SECRETARY OF THE INTERIOR'S STANDARDS REVIEW

**FOR A PROPOSED ADDITION PROJECT
FOR AN
HISTORIC GOTHIC REVIVAL CHURCH**

Saint Herman of Alaska Orthodox Church

161 North Murphy Avenue
Sunnyvale, California
(Parcel Number 204-49-031)

Plot Plan

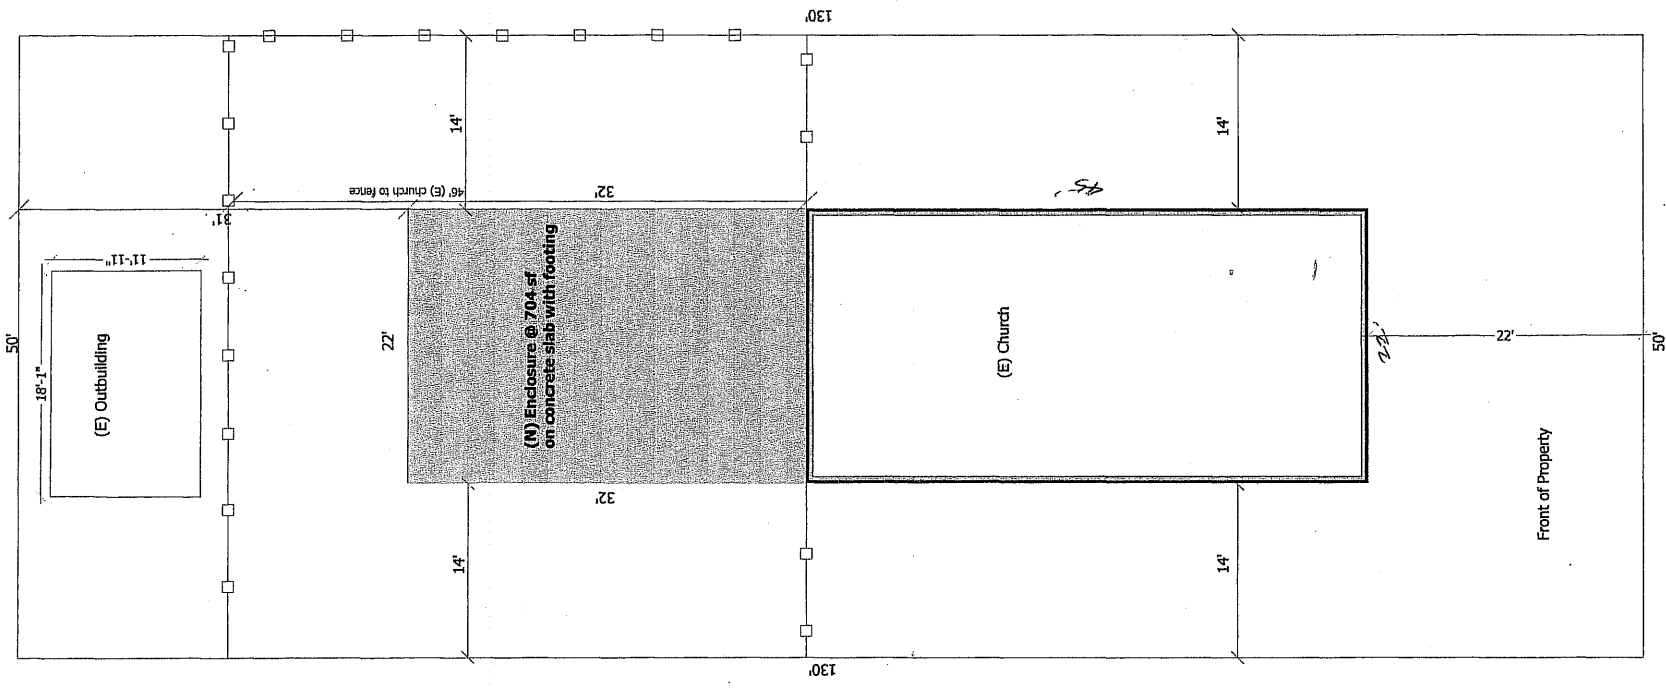
There is one discrepancy in the drawing dimensions that needs to be addressed. The plan graphically shows the addition narrower than the original building, but the dimensions show the addition to be 22', the same as the existing building. It is recommended that the width of the proposed addition be reduced to less than 22' to maintain the original building as the primary structure.

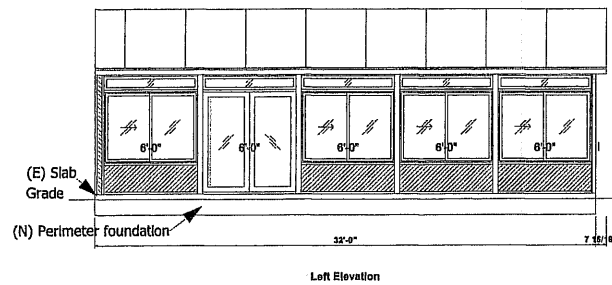
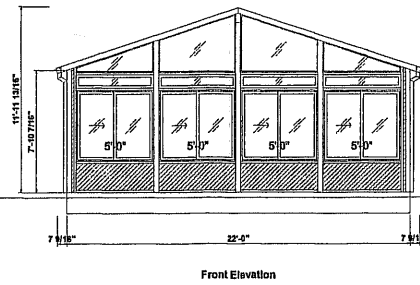
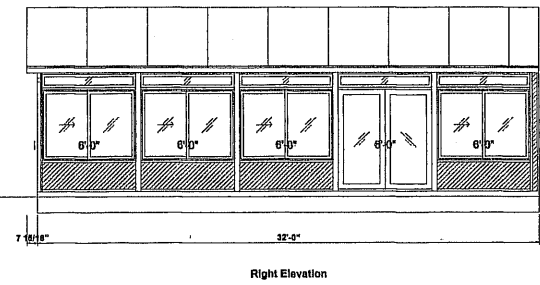
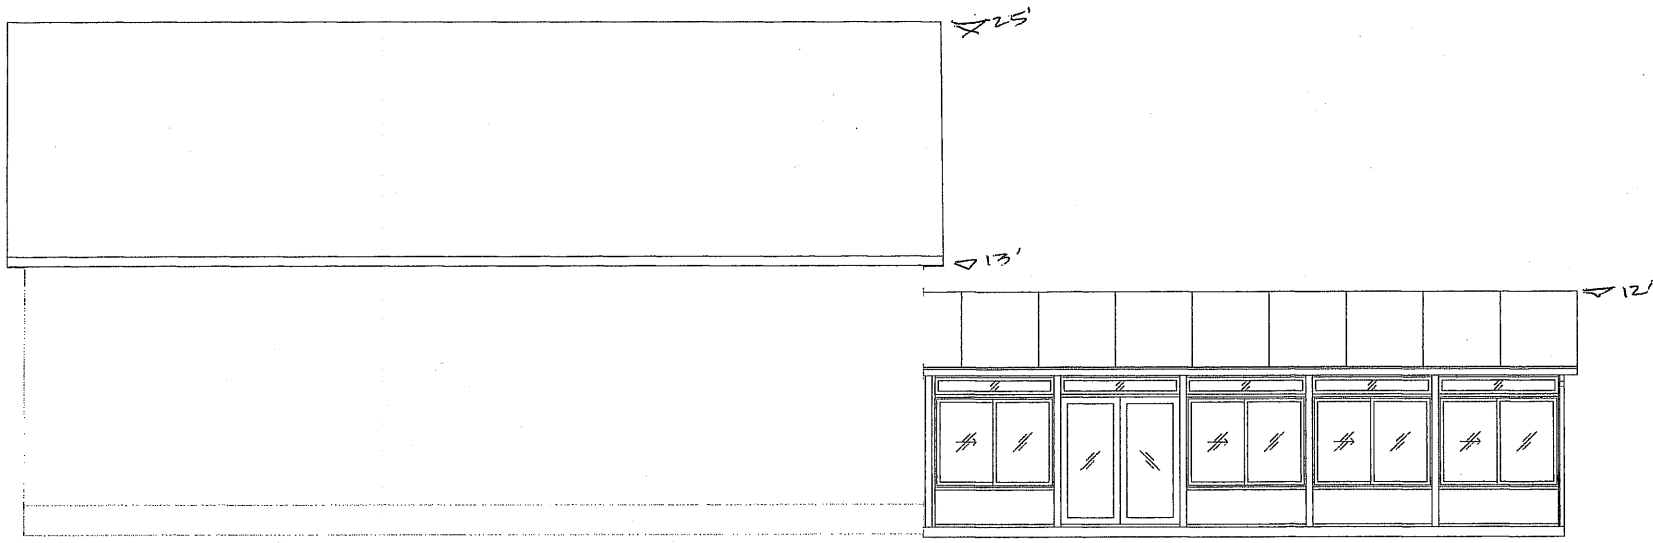
The currently proposed white aluminum finish with white paneling would be very bright and shiny; this color and material combination would draw attention to the addition, away from the historic building. It is recommended that the finish material of the aluminum be changed to bronze anodized. This color would recede visually, and would blend with the roof color and trim color of the main building. It is also recommended that the panels be painted to match the off-white color of the church, or to match the trim; white would be incompatible.

The simulated skip-trowel finished paneling proposed for the addition is not compatible with the smooth siding and traditional design of the historic building. It is recommended that a smooth finish be provided; apparently, a stippled/sand finish base panel is available.

It is recommended that the drawings clearly state that the proposed roof shingles on the addition shall match the church shingles. (This is understood, but not currently documented.)
